CHARTER TOWNSHIP OF VAN BUREN
PLANNING COMMISSION AGENDA
Wednesday, January 24, 2018 – 7:30 PM, Board of Trustees Room

ITEM #1: **CASE 14-007 – SITE PLAN AMENDMENT**

TITLE: **THE APPLICANT, MENARD, INC, IS REQUESTING A SITE PLAN AMENDMENT IN ORDER TO MAKE MINOR MODIFICATIONS TO THE APPROVED ELEVATIONS OF THE PROPOSED MENARDS STORE AT 10010 BELLEVILLE ROAD.**

RE: **Menards Site Plan Amendment to Modify the Exterior Elevation of the Building.**

1 A-201 FRONT ELEVATION

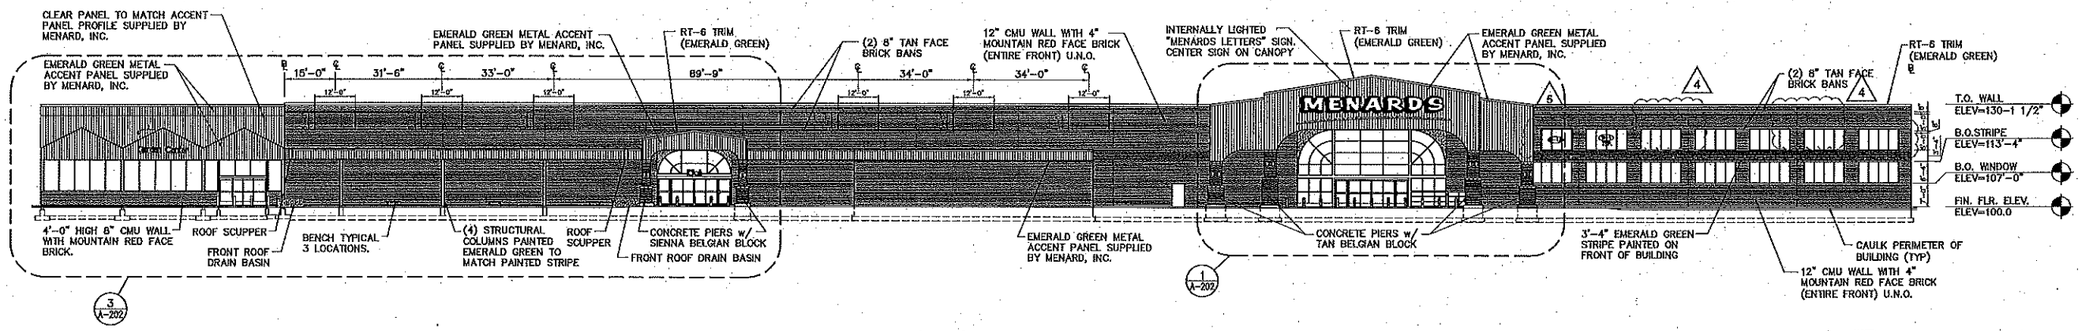
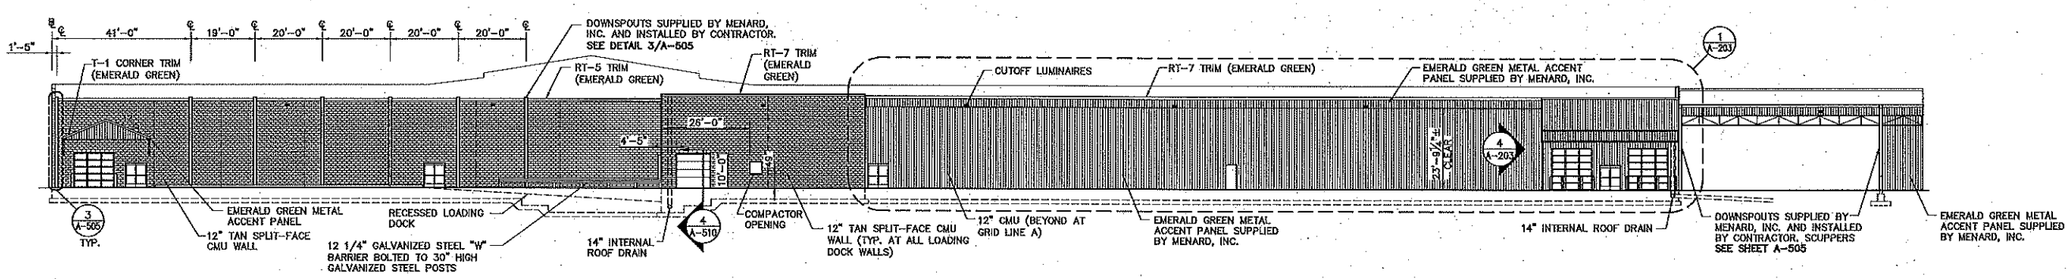
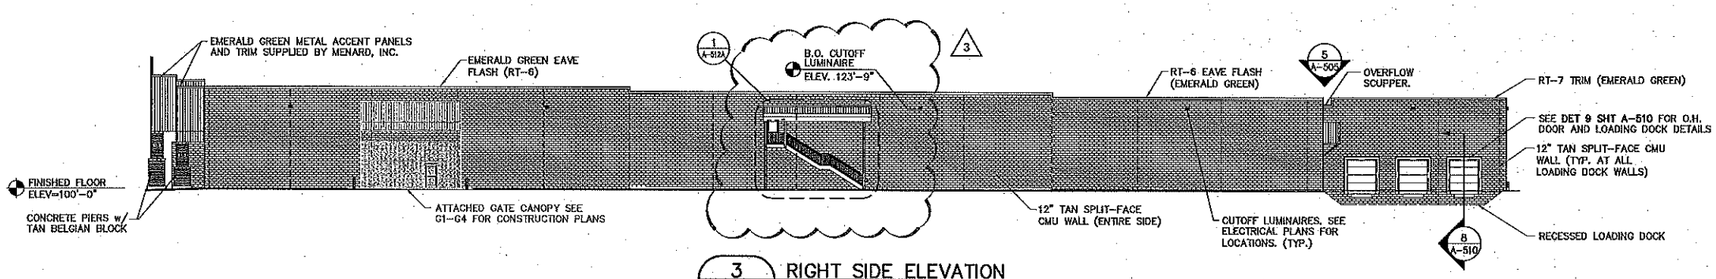
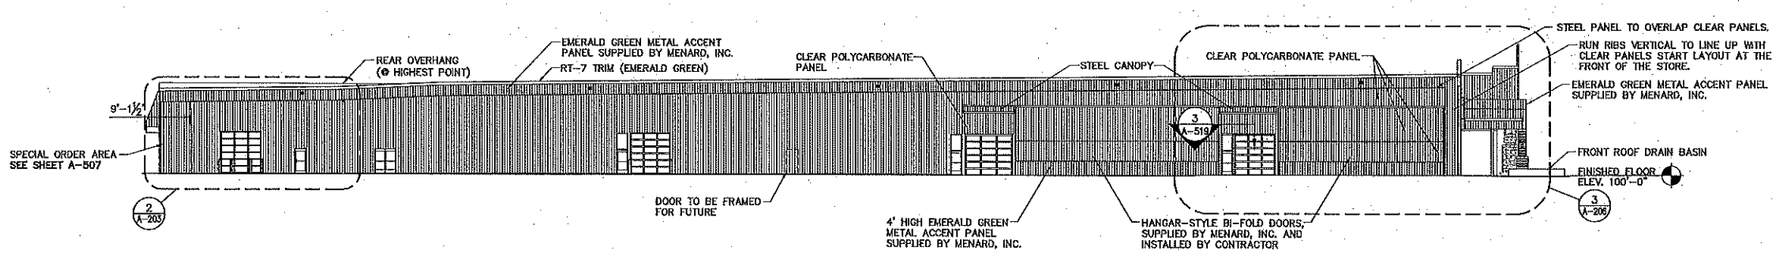
The Menards Store received site plan approval in early 2017 and has since began construction. As construction has progressed, Menards is proposing to make a modification to their building plans to add additional area in their second story mezzanine structure within the building. Township staff has reviewed the updated building plans and have noted two minor alterations to the elevations of the building which will require Planning Commission approval. First, on the front elevation, the applicant is proposing to add several additional windows on the northern end of the front elevation. These windows will provide day light for the mezzanine. The second minor alternation is with regards to a stairway on the northern face of the building. I will review these two minor modifications based on the criteria in the Zoning Ordinance.

The setback of the additional stairwell will need to be evaluated as it protrudes from the building. The required side yard setback for the C-2 district is 25'. Based on the location of the stairwell on the exterior of the building and the approved site plans the proposed side yard setback for the stairwell would be greater than 60' and would meeting the minimum setbacks. In addition to this there is existing screening present from the initial site plan approval and due to this the impact on the adjacent properties would be limited. Based on the above review the stairwell is consistent with the Zoning Ordinance.

the addition of the windows does not change the primary building material from brick. Based on this, the applicable zoning standards have been met.

Staff recommends that the Planning Commissions approve the request to amend the approved site plan for the Menards development at 10010 Belleville Road in order to incorporate the addition of the windows on the front façade of the building and the stairway on the north elevation of the building, as depicted on the building plans dated 12-1-17. Approval shall be based upon Township staff report January 19, 2018 and the finding that the proposed elevations are compliant with the Township Zoning Ordinance.
